ADDENDUM #1

DATE: July 9, 2024
TO: All Bidders
FROM: Donald R. Ernat
SECTION: 24-14865-00-DR, Grand Rapids Township

SECTION
 24-14865-00-DR
 PLAN AND PROFILE
 LASALLE COUNTY
 HIGHWAY DEPARTMENT
 1400 N. 27TH ROAD - P.O. BOX 128 - OTTAWA, ILLINOIS 61350
 PHONE (615) 434-0743 FAX (615) 434-0747
 PLEASE DRIVE SLOWLY
 HWY. NO.
 E 21ST RD
 SHEET NO.
 5 of 10

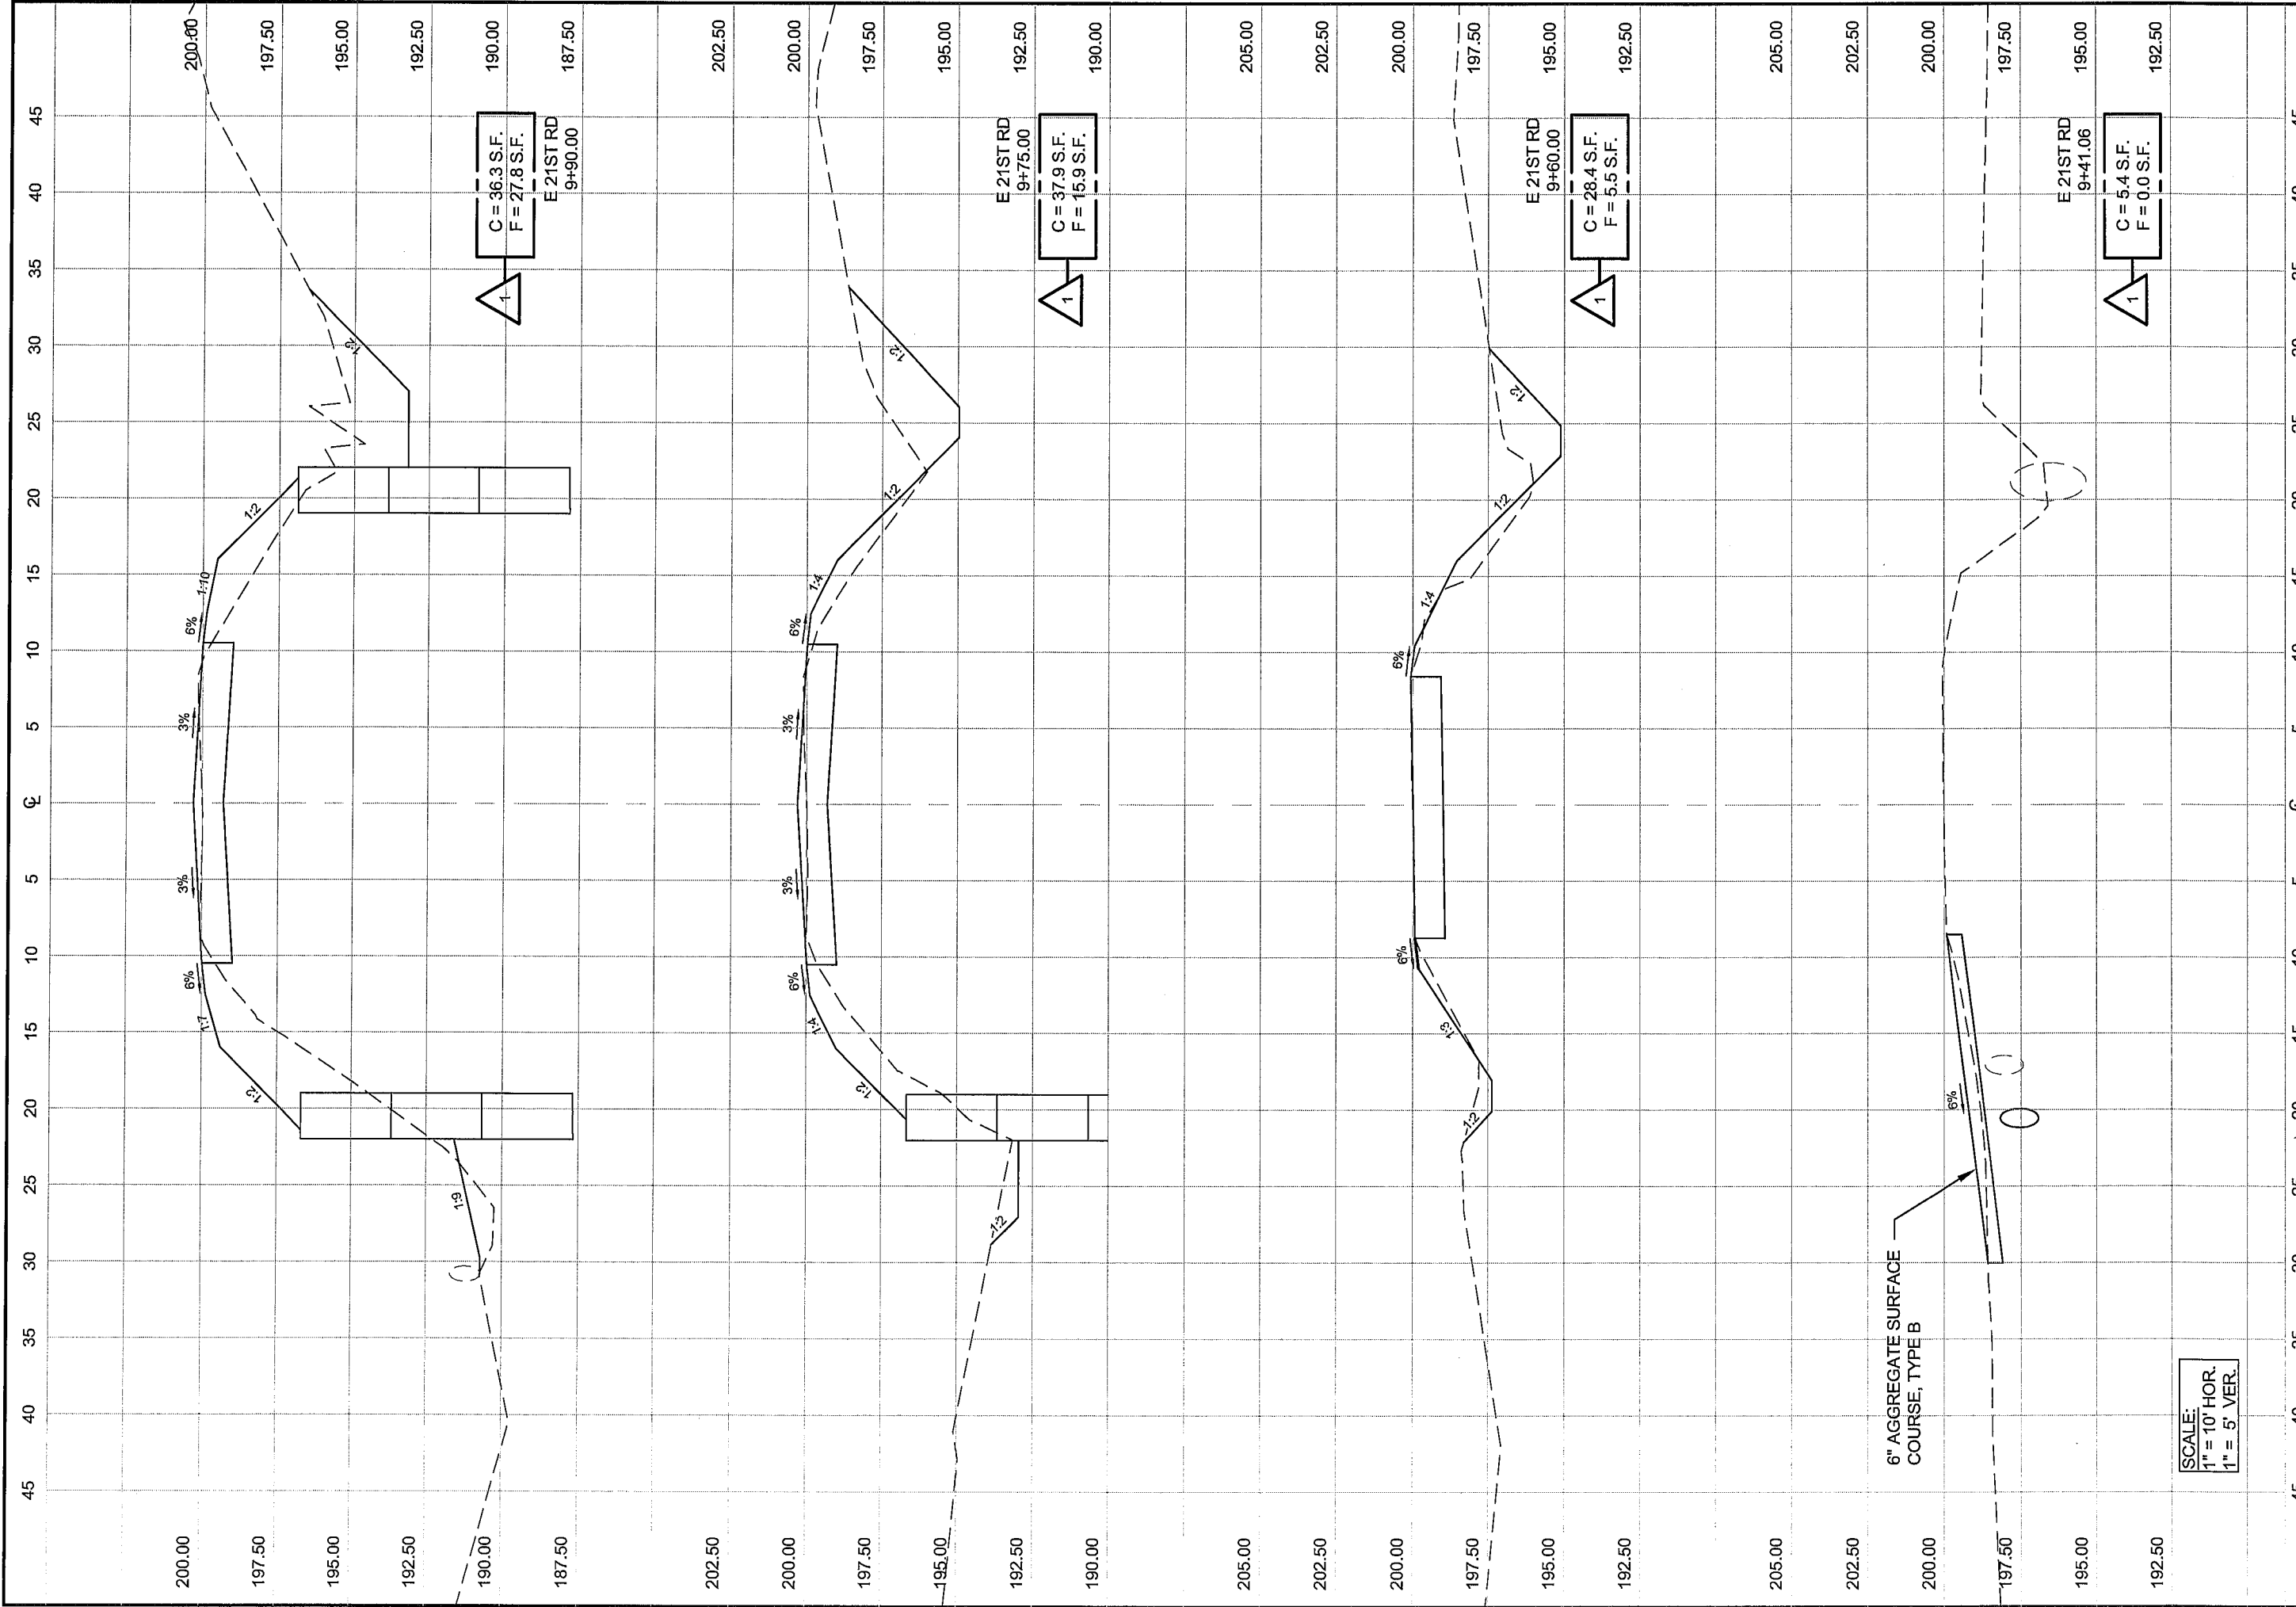
1. Replace Plan Sheet 5 of 10 with the attached REVISED. The profile view has been added.
2. Replace Plan Sheets 9 & 10 of 10 with the attached REVISED. The cuts & fills have been added.
